Access Compliance Report Public Rights-of-Way (Curb Ramps)

Intersection ID: 23481Main Street: ALEXANDER_RDCross Street: PROVIDENCE_RDLocation: SWADA ID: A4018B9EA8F8Ramp Type: PerpInitial Pass/Fail: FailOverall Compliance: NoSeverity Score: 33.75

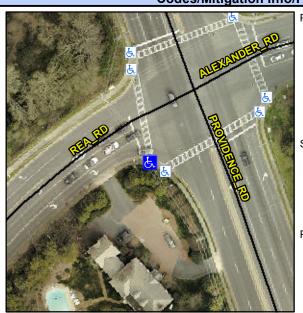
Possible Solutions:						
Remove & Replace Entire Ramp.						
	- 1					
Surveyor Notes:						
N/A						
PROW/ADA:						
Not Found, R304.5.1, R304.2.2,						
R304.5.3

Field Measurements/Component Compliance							
Compliance Description		Data	Comp	liance Description	Data		
N/A	Ramp Length (in)	72.0	No	Ramp Slope (%)	8.8		
No	Ramp Width (in)	45.0	No	Ramp XSlope (%)	6.3		
N/A	Flare Type LT	N/A	N/A	Flare Type RT	N/A		
N/A	Flare Slope LT (%)	N/A	N/A	Flare Slope RT (%)	N/A		
N/A	Flare Traversable LT?	N/A	N/A	Flare Traversable RT?	N/A		
N/A	Landing Length (in)	N/A	N/A	DWS Provided?	N/A		
N/A	Landing Width (in)	N/A	N/A	DWS Contrast?	N/A		
N/A	Landing Slope (%)	N/A	N/A	DWS Length (in)	N/A		
N/A	Landing X Slope (%)	N/A	N/A	DWS Full Width?	N/A		
N/A	Landing Curb? (Y/N)	N/A	N/A	DWS Offset (in)	N/A		
N/A	Shared Landing?	N/A					
N/A	Gutter Ponding?	N/A	N/A	Gutter Slope (%)	N/A		
N/A	Gutter Lip Ht (in)	N/A	N/A	Gutter X Slope (%)	N/A		
N/A	Painted X Walk1?	Yes	N/A	Painted X Walk2?	N/A		
	X Walk 1 Direction	To N		X Walk 2 Direction	N/A		
N/A	X Walk 1 Width (in)	66.0	N/A	X Walk 2 Width (in)	N/A

X Walk 1 Slope (%)	7.8		X Walk 2 Slope (%)	N/A		
	X Walk 1 X Slope (%)	6.3		X Walk 2 X Slope (%)	N/A		
N/A	Ramp inside XWalk1?	Yes	N/A	Ramp inside XWalk2?	N/A		
	Road Slope (%)	N/A	N/A	Clear Space?	N/A		
	Road X Slope (%)	N/A	N/A	Clear Space to XWalk (in)	N/A		
N/A	Any Obstructions?	N/A	N/A	Storm Grate/Utility Hazard?	N/A		
	Obstruction Type			Storm Grate/Utility Type			
		N/A			N/A		
			Yes	Surface Condition? (G/P)	Good
